# County of Fairfax, Virginia

## **STAFF REPORT**

**APPLICATION SEA 81-M-097-4**

**APPLICANT:** CCP Shirley Highway, Inc. and Petroleum Marketing Group Inc.

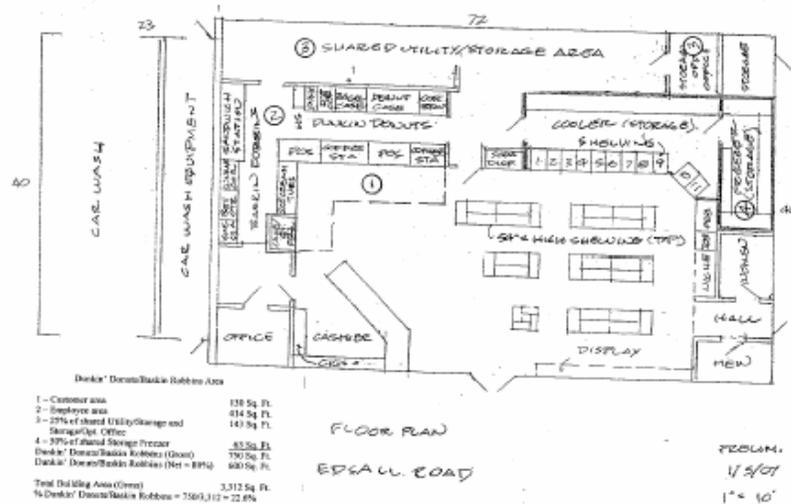
The bank building is a single story, flat-roofed structure with taller, gabled elements at both the northern and southern ends. The multi-use building has a flat roof that is varied in height, with a gabled element on the highest middle section. As stated, no materials are indicated for these buildings, either on the elevations or in supporting materials; however, the elevations appear to be brick and some other material, possibly glass. Both buildings show arched window details, as shown in the elevations below.

The proposed bank is located on the western portion of the site, adjacent to the “main street” entrance road to the Jefferson at Sullivan Place development. Two drive-through lanes and canopy are shown on the eastern side of the building. The plat indicates that the building will be 3,800 square feet in area, with a maximum height of 35 feet. As shown in the elevations below, the majority of the building will be one-story with a taller feature at the north and south ends of the building. The applicant has verbally indicated that the bank will include a walk-up ATM on the building, which would be beneficial given the surrounding residential complex.

The applicant has requested no limitations on the hours of operation for the bank because they have not identified a bank tenant at this time.

The applicant has provided elevations for both buildings proposed on the application property, showing the fronts, but not the rears (or the sides of the multi-use building). Because all sides of the development are visible, facing a “front” road, into the active areas of the site, or abutting residential (with minimal screening and no barrier), staff is particularly concerned about these facades. Additionally, while the elevations appear to be brick, no actual materials or colors are provided. Relating to signage, a note indicates that signage will be coordinated with the CSP approved on the adjacent property, but does not indicated how, and goes on to say that “dimensions, details, color, copy, font...” may change. Finally, the entire elevation sheet is labeled “for information only.”

Staff has therefore proposed development conditions requiring the applicant to provide treatments on the rears and sides of the buildings that is comparable to that on the fronts, and will require that building and signage materials and colors be demonstrated to be coordinated with those in the surrounding development.

6. Irrespective of the note on Sheet 8 of the SE Plat, architecture shall be in substantial conformance with that shown on the SE Plat, and shall utilize brick as the primary building material. Prior to building permit approval, it shall be demonstrated to DPWES that the colors and materials used are consistent with those used in the commercial buildings on the western side of Sullivan Place Drive.

7. Architecture on the rear (south side) of the buildings shall be substantially in conformance with that shown for the front (north side); architecture on the other two sides of the building shall be consistent in terms of materials and style with the elevations shown.

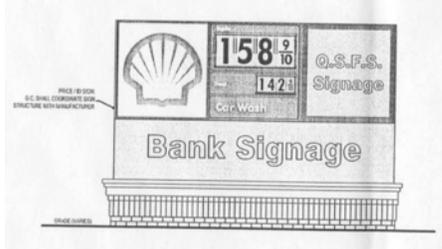
The proposed fast food use would be, as described by the applicant, a Dunkin Donuts and Baskin Robbins combination, selling doughnuts, bagels, muffins, etc., prepared breakfast and lunch sandwiches, coffee and other beverages, and ice cream, sundaes, shakes, malts, etc. According to the floor plan provided by the applicant, 750 gross square feet would be utilized by this use (600 net square feet), or 22.6% of the gross floor area of the building. The use, as shown on the floor plan, would have separate counters and registers from the service station/quick service food store. The floor plan does not show any counter or table seating for the use (nor is any accounted for in the parking tabulations), but there could be room in center of the store for limited seating. Additionally, the applicant has verbally requested that outdoor seating be allowed for the use. No area on the SE Plat is shown for such outdoor seating, nor does there appear to be any area where such seating could be provided, other than in the sidewalk along the front of the store (8 feet wide). The applicant has requested that the hours of operation be 24 hours a day/seven days a week.

The applicant's proposal would replace three (or four) uses in three older buildings with five uses in two new buildings. The proposal would increase the gross floor area on the site by 35%, and increase the expected traffic generation by approximately 52%. While revitalization of this site is clearly desirable, staff believes that approving too much on this site in an attempt at revitalization will not be an improvement. The applicant has worked with staff to reduce the initial requests, dropping a drive through bank lane and a service station pump island, reducing the size of the proposed bank by 200 square feet, and reducing the area devoted to fast food within the service station by 90 square feet.

Staff remains concerned, however, that the proposal is simply too much for the site. Staff therefore has proposed that that the request be approved in part, rather than as proposed. Specifically, staff has proposed that the fast food and car wash uses be denied. In addition to a general reduction in activity and intensity, this would allow the area currently shown as car wash and its stacking spaces to become landscaped open space, better screening the existing residential uses to the south and east. Denying the fast food as a separate use would also reduce the required parking by five spaces. As there are at least four parking spaces on the site that staff believes are highly undesirable and dangerous, this would allow those spaces to be deleted and replaced with landscaped open space without negatively impacting parking, further screening the front entrance of the adjacent residential development from the new auto-oriented uses in its front yard.

3. Irrespective of that shown on the SE Plat, no separate fast food use, as determined by the Zoning Administration Division, shall be included in the service station/quick service food store.
